INTEGRA MINE COMPLEX

Emplacement Area Modification (08_0101 MOD 1 and 08_0102 MOD 1)

Figure 5: Proposed Modification (Emplacement Extension Area 9 and Crib Site Relocation)

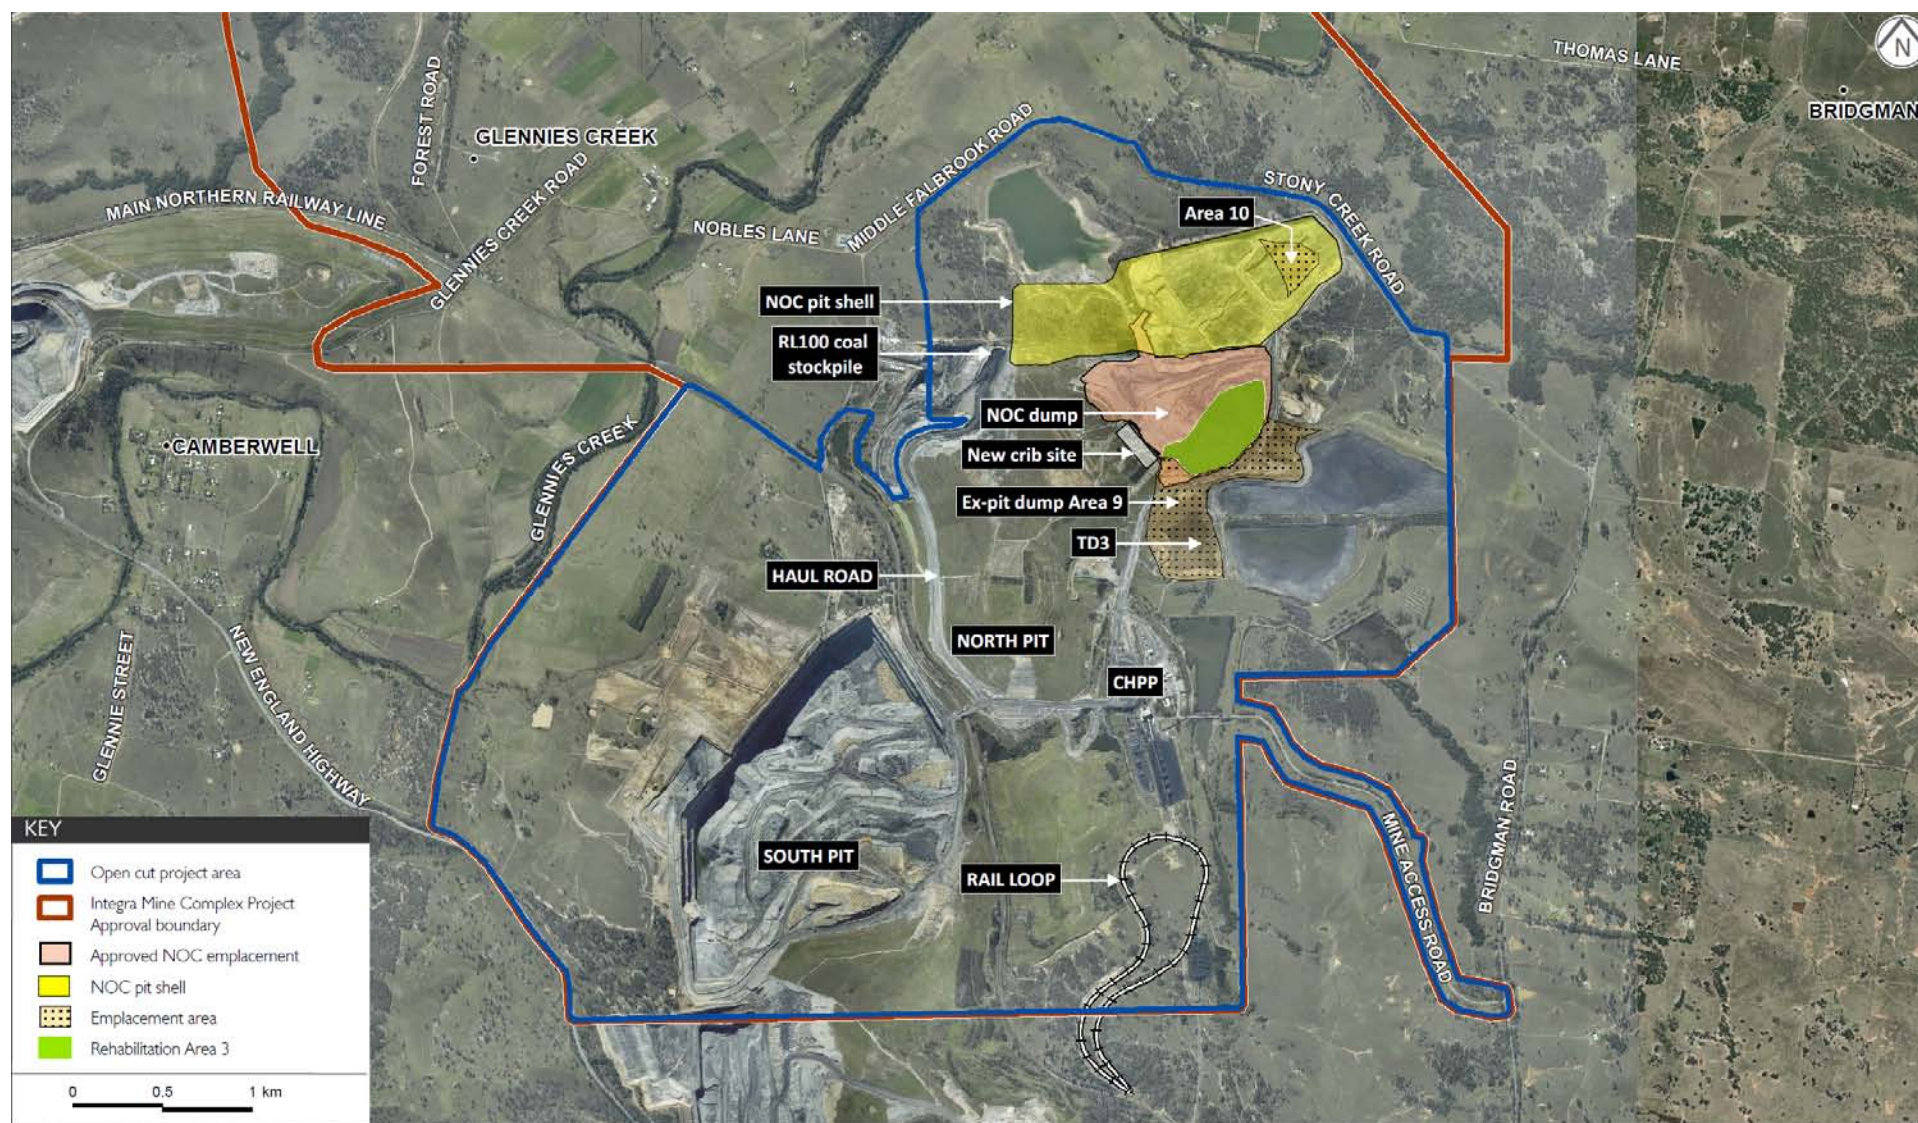
Integra recently reassessed the overburden emplacement requirements for the North Open Cut and identified a critical lack of dump space that would affect continued extraction from the pit. To address this constraint, Integra is seeking to extend the area and height of the NOC dump to the east and south, into an area referred to as ex-pit dump Area 9 (see Figure 5).

The proposed extension covers an area of 32 ha, extending the approved out-of-pit emplacement from 43 ha to a total of 75 ha. Figure 5 shows the approved emplacement area (labelled NOC dump) and the proposed extension (labelled Area 9). The extension would also involve the capping of Tailings Dam No. 3 (labelled TD3). The height of the emplacement would be increased from the approved 135 metres Australian Height Datum (m AHD) to 141 m AHD. The extension is required to provide sufficient overburden dumping space until 2015, allowing continued extraction from the North Open Cut until that time.

Integra proposes to relocate an existing crib hut site and associated infrastructure to accommodate the extension to the NOC dump. The crib site would be relocated from the eastern side of the emplacement area to the west (see Figure 5). Facilities to be relocated include two portable buildings, an ablution block, office and a 5,000 litre water tank. Some additional facilities would be constructed at the new crib site, including a second 5,000 litre water tank, a diesel/electric generator and a covered truck parking area (8.5 m²).

Integra has provided responses to the issues raised in submissions (see **Appendix C**). In response to the concerns raised by the EPA, Integra subsequently revised Area 9 to ensure that it does not encroach on the Southern BOA, reducing the proposed extension to the NOC dump from 39 ha to 32 ha. Integra also agreed to revise the mine's Water Management Plan and consult with NOW if required. The Department has considered the issues raised, and Integra's response to these issues, in its assessment of the proposed modification.

Figure 6: Nearest residences and air quality monitoring locations

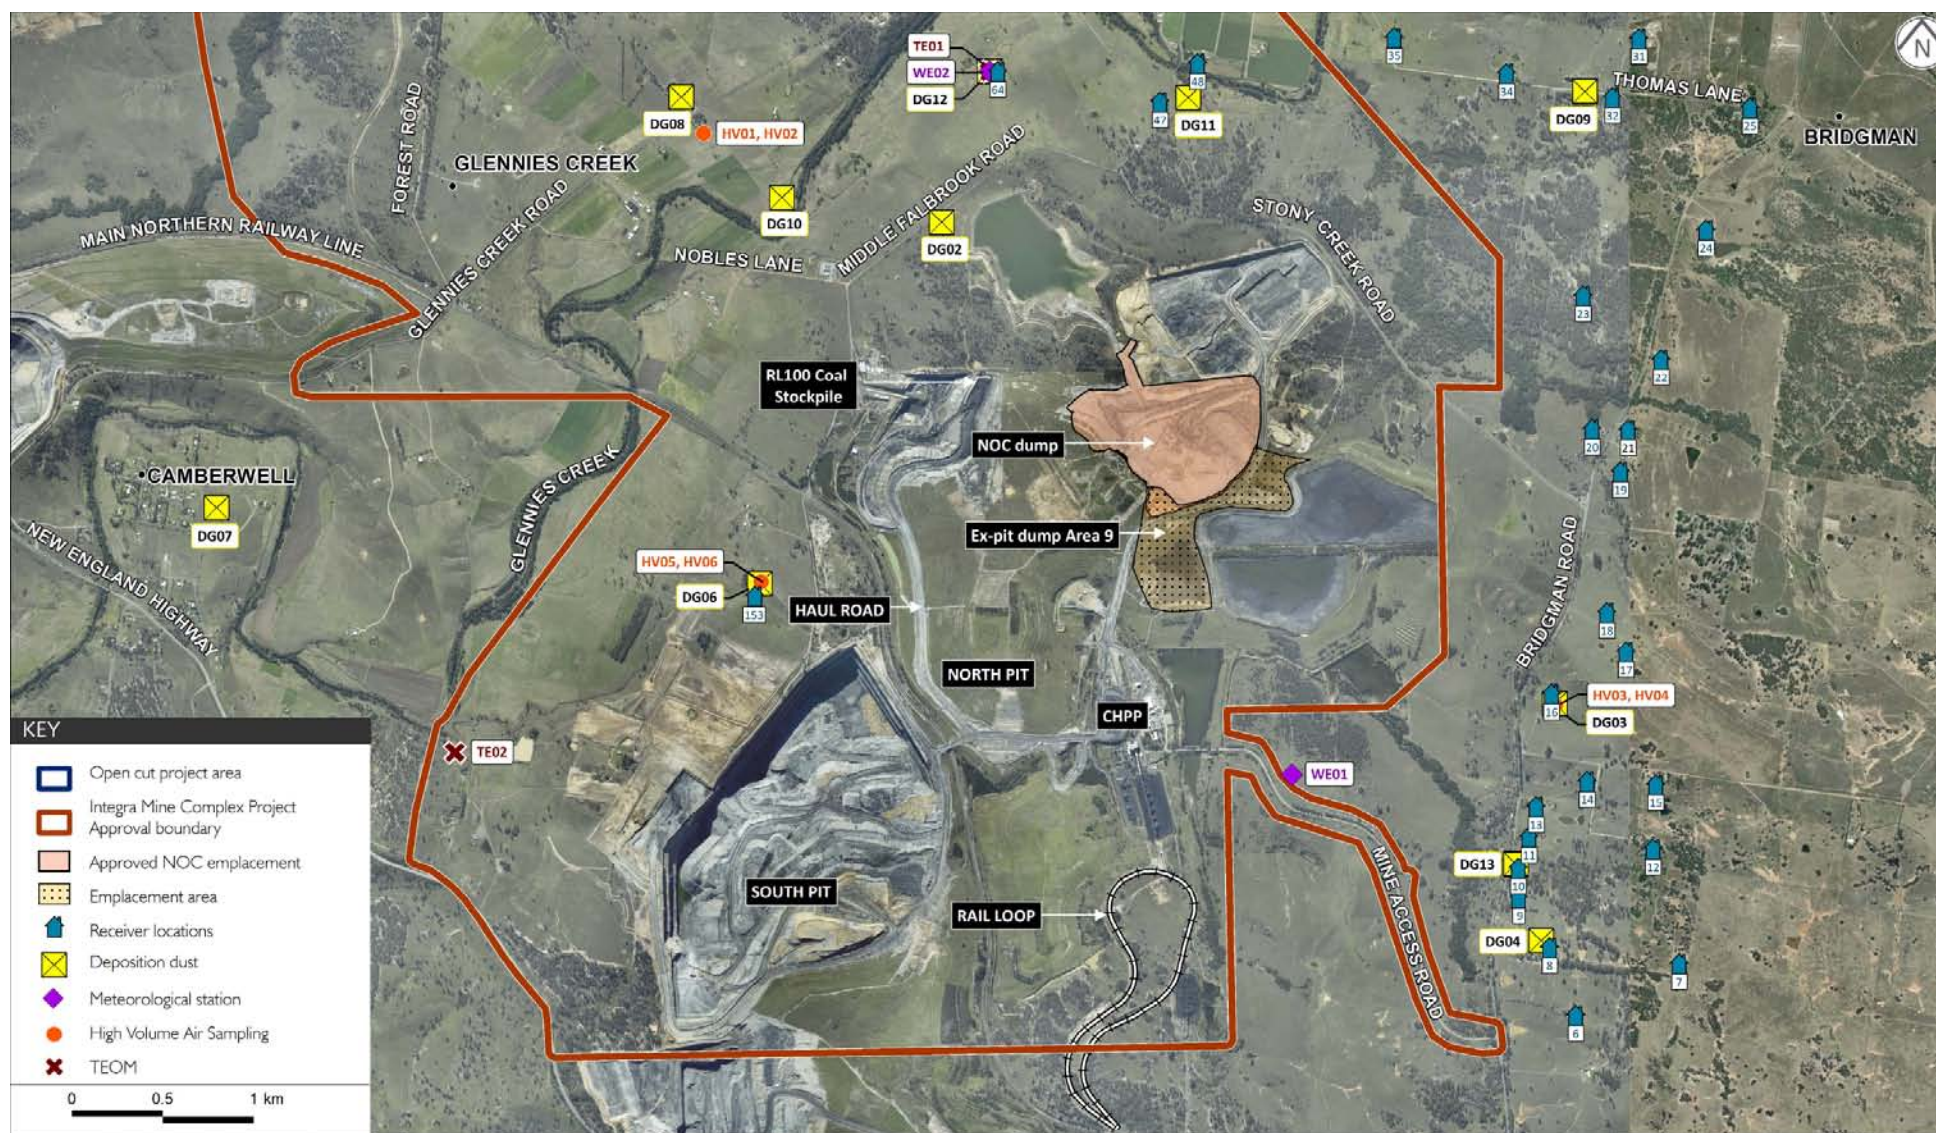
The nearest residences and air quality monitoring locations are shown on Figure 6. Submissions were received from two residences to the north, with both raising concerns over increased dust impacts. Residences to the north are currently located 1 km from the North Open Cut and 2 km from the NOC dump. The *Dulwich* property is located 2 km west of the emplacement area and would remain at a similar distance from the extended emplacement area. These distances would remain unaffected since the proposed extension is to the south and east. The proposed modification would result in the emplacement area moving 500 m closer to the residences to the east and southeast (located 1.5 km from the proposed boundary of Area 9). The EMGAMM assessment indicated that prevailing winds are from the northwest and southeast and residences to the southeast would be the most impacted.

EMGAMM estimated that total dust emissions would increase slightly as a result of the modification with 0.77 kg of TSP/tonne of ROM coal extracted compared with 0.74 kg under approved operations. However, predicted TSP, PM₁₀ and deposited dust levels would remain below relevant air quality impact assessment criteria at all residences to the east, north and south. It was considered that residences to the west would not experience a change in impacts.

Whilst the Department agrees that the modification would not increase dust emissions to unacceptable levels, it is nonetheless reasonable that all contemporary best practice dust control measures are implemented by Integra to ensure that impacts are minimised. The independent review reiterated the Department's view that proactive management is required to ensure compliance with the project approval and maintain dust at an acceptable level at nearby residences.

Figure 7: Nearest residences and noise monitoring locations (Independent review June – October 2011)

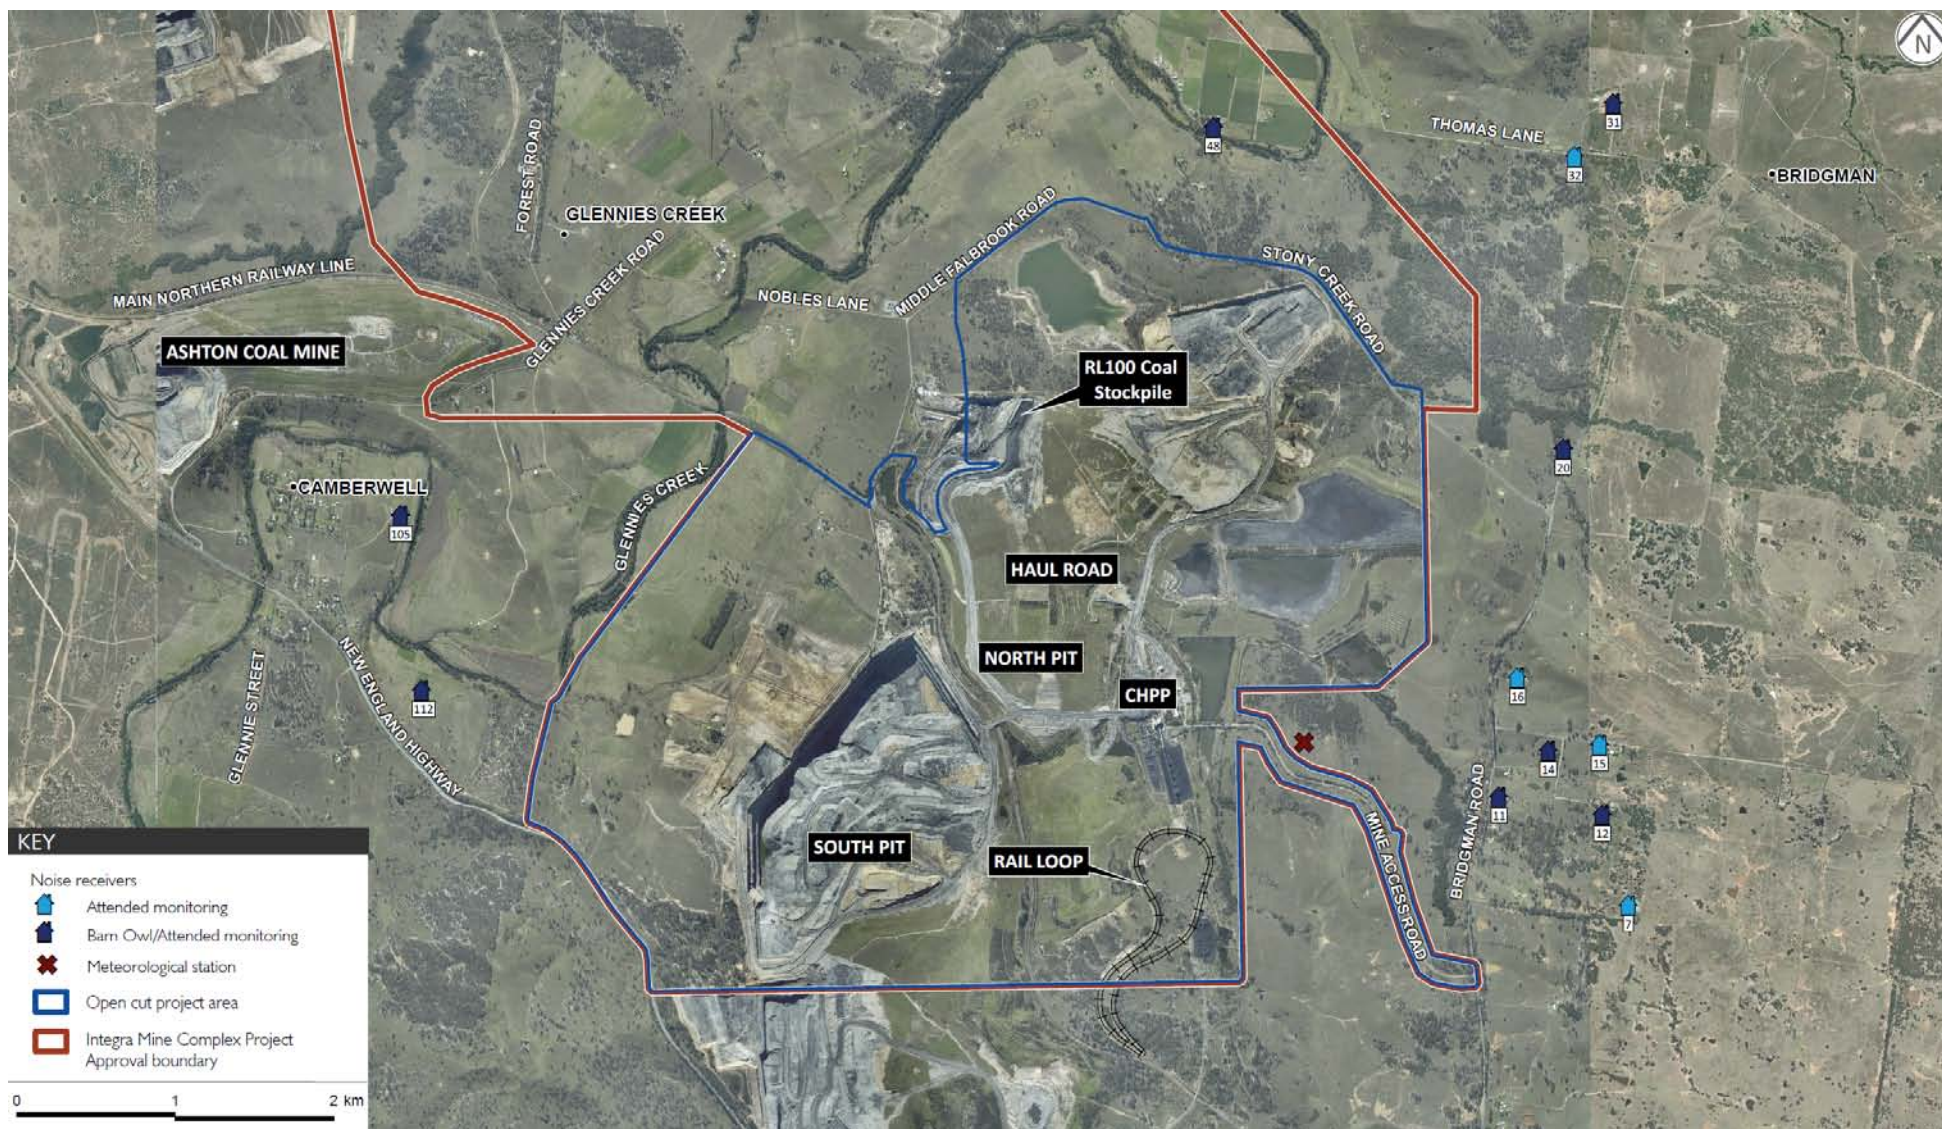
The EMGAMM review of noise impacts over the period June to October 2011 addressed 11 residences surrounding the mine (see Figure 7). This review concluded that:

- operational noise criteria were exceeded at three properties to the north and east of the mine (residences 20, 31 and 48). These exceedances were limited, occurring once or twice over 11 or more monitoring occasions, and ranging from 2 to 10 dBA above criteria;
- there were some isolated exceedances of mitigation criteria at residences to the west and east (residences 105, 112, 11 and 14). These exceedances covered 0.5% to 4% of the total monitoring period, and were therefore not considered to be "systemic"; and
- there were some isolated exceedances of acquisition criteria at residences to the west and east (residences 105 and 11). These exceedances covered 0.2% and 1% of the total monitoring period, and were also not considered to be "systemic".

The independent review provided a number of recommendations to address these non-compliances, including:

- update the Noise Management Plan for the mine complex to address the modification, as is required under the project approval; and
- implement the recommendations of the EMGAMM independent review including:
 - offering noise mitigation at residences 20, 31, 32 and 48;
 - offering acquisition upon request to residence 11; and
 - augmenting the monitoring program to include additional residences, directional and attended monitoring.

Figure 8: Vegetation communities in the area

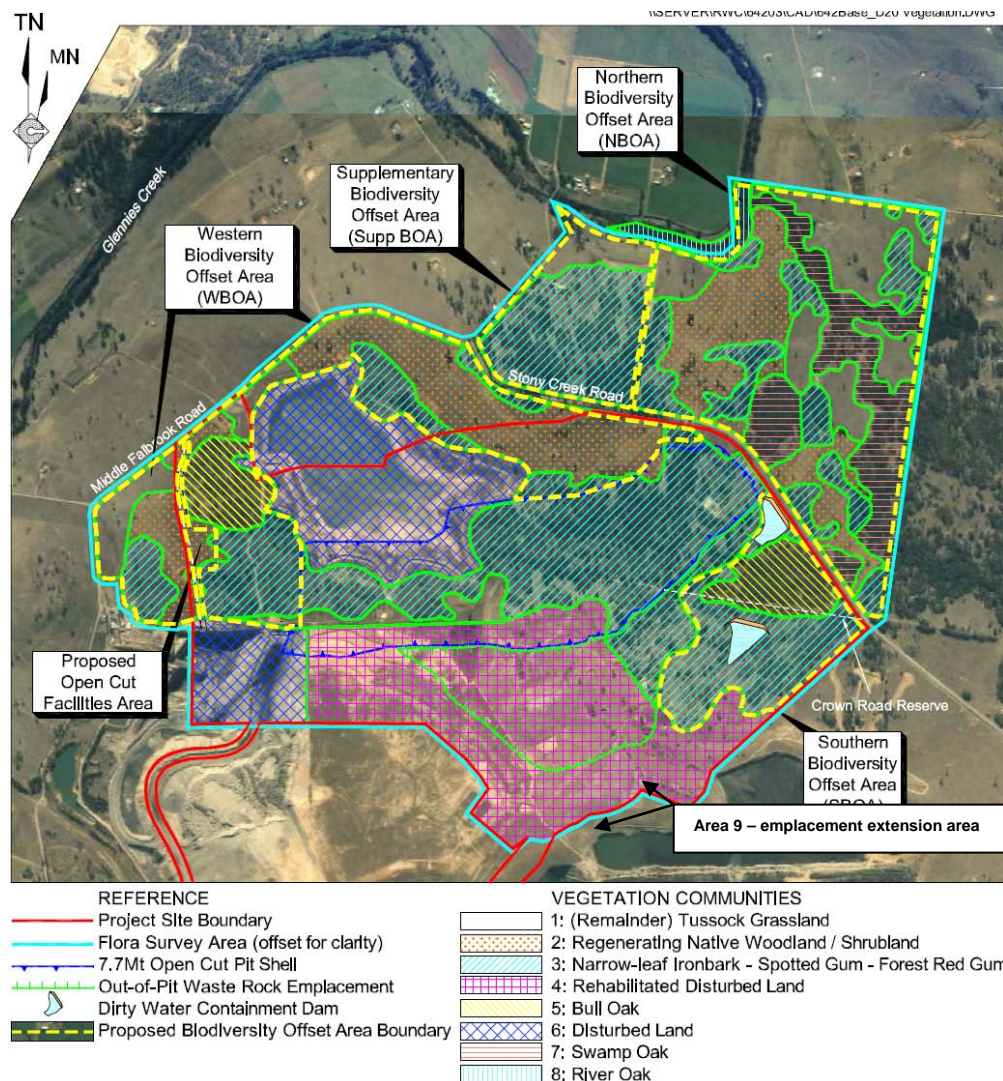
Figure 8 shows the vegetation communities and the previously approved NOC dump, as surveyed for the North Open Cut EA in 2007. Parts of the NOC dump extension were not covered by this ecological survey. However, these areas were previously disturbed by mining activities and have little ecological value. The NOC dump extension and crib site would impact only on areas of previously disturbed land and a small area of land previously rehabilitated by Integra. Extension of the NOC dump and construction of the crib site would require removal of a small number of immature planted trees and shrubs. The Department concludes that, following the amendment of the proposed NOC dump extension to exclude 7 ha of the proposed Southern BOA, the impacts on biodiversity from this component of the modification would be negligible.

Figure 9: Biodiversity Offset Areas (BOAs)

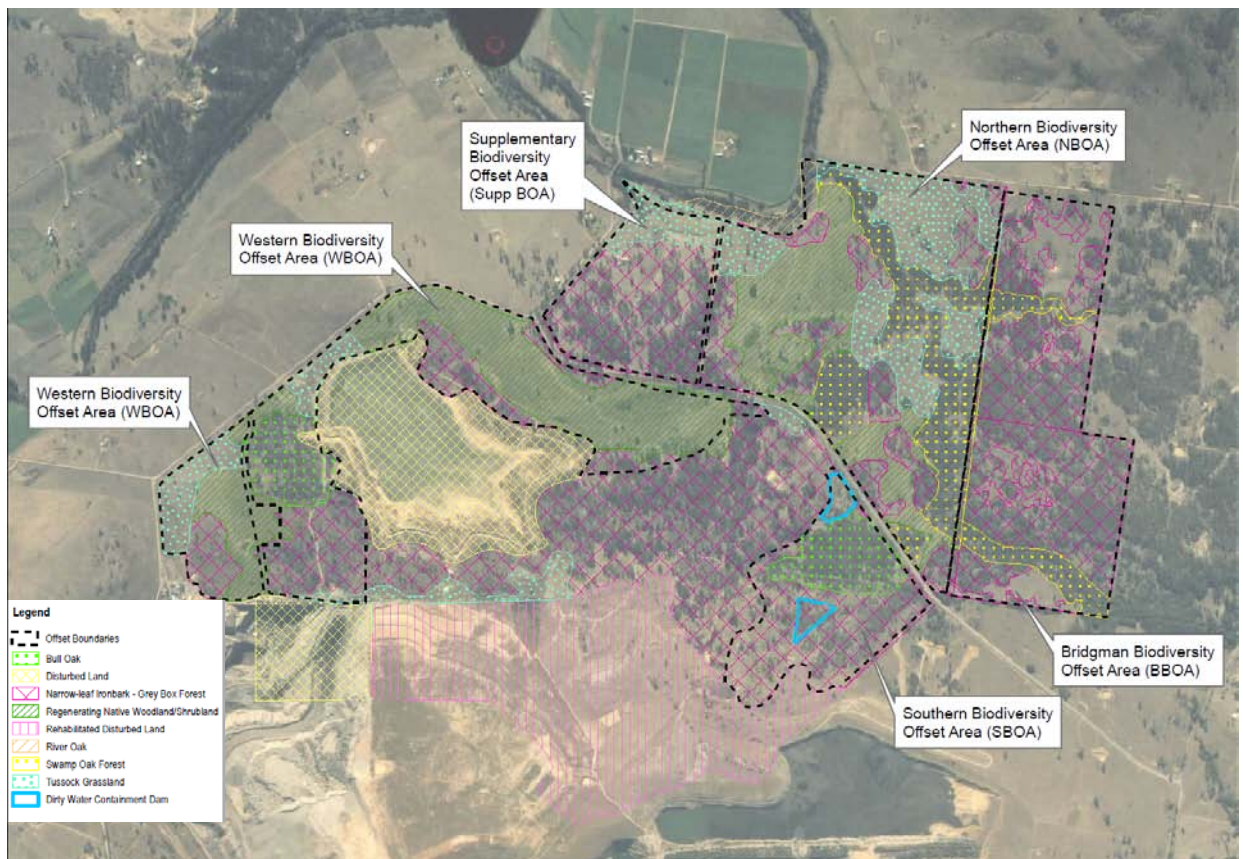
The Department acknowledges that Integra has reported on some of these improvement works such as planting and weed removal within the Northern and Supplementary BOAs, installation of nest boxes, and the exclusion of livestock from all BOAs. However, the current vegetation condition within the BOAs is uncertain and it is unclear whether the performance monitoring described in the Landscape Management Plan has been undertaken. The Department and OEH also note that it appears that some clearing of native vegetation may have taken place within the southwestern fringe of the proposed Southern BOA since the 2007 survey of vegetation communities, based on a comparison of the aerial photograph basemap used in Figure 5 (part of the modification EA) and Figures 8 and 9 (from the 2007 Glennies Creek Open Cut EA).

In summary, the Department considers that more substantial measures could have been implemented by Integra to protect and manage the BOAs since they were first set aside in 2008.

Whilst delaying the implementation of the biodiversity conditions by 15 months (condition 42) and 9 months (condition 43) is unlikely in itself to have significant impacts, the Department considers that it is very important that all of Integra's BOAs are appropriately managed in the interim, until such time as the formal offset strategy is finalised, approved and implemented. While accepting Integra's rationale to extend the deadlines for meeting conditions 42 and 43, the Department is proposing that Integra commission an independent audit of all the BOAs to:

- report on current baseline data on flora and fauna within the BOAs, including the condition of key vegetation communities;
- compare the current condition of the vegetation communities within the BOAs to that surveyed in 2007, including a report on any works and/or other disturbance that has taken place since those surveys;
- evaluate the effectiveness of management measures undertaken to date in improving the biodiversity value of the BOAs; and
- recommend any additional improvement works and provide a schedule for their implementation.

The recommended conditions require that this audit report must be provided to the Department by the end of July 2012, which would allow the audit report to be considered in conjunction with the revised offset strategy and proposed arrangements for long term security.
